Thank you for purchasing the PG-FP5 flash memory programmer.

This document describes specifications that have been added or changed, restrictions, and cautions on using the PG-FP5. Also see the user's manual of the PG-FP5 for terminology and points for caution on using the PG-FP5.

Chapter 2 Additions and Changes to Specifications

No. 1 Modification of **Cancel** button specification

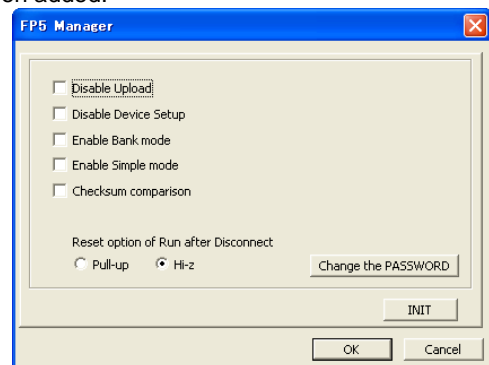
Description: The function of the **Cancel** button on the PG-FP5 main unit has been modified so that cancellation, which was applied to all commands, is only applied to the **Read** command.

Implementation: This item has been implemented in products with control code A (firmware: V1.01, FPGA: V1, GUI: V1.00).

No. 15 Addition of **Wide Voltage mode** function

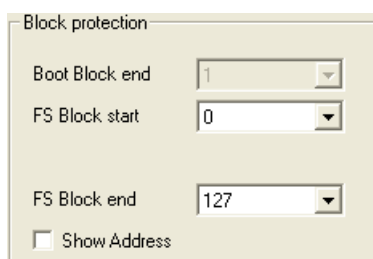
Description: The **Wide Voltage mode** check box has been added to the **Command options** area. If this check box is selected, commands are executed in the wide voltage mode. If this check box is not selected, commands are executed in the full-speed mode. This check box is available when a device supporting this function is selected. For details about the wide voltage mode and full-speed mode, see the user's manual of each device.

Implementation: This item has been implemented in products with control code A (firmware: V2.02, FPGA: V2, GUI: V2.02).

No. 16 Change of layout in **Block protection** area

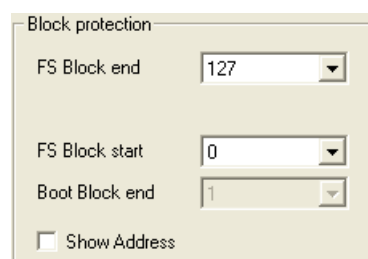
Description: The layout in the **Block protection** area has been changed.

Before change

After change

Implementation: This item has been implemented in products with control code A (firmware: V2.02, FPGA: V2, GUI: V2.02).
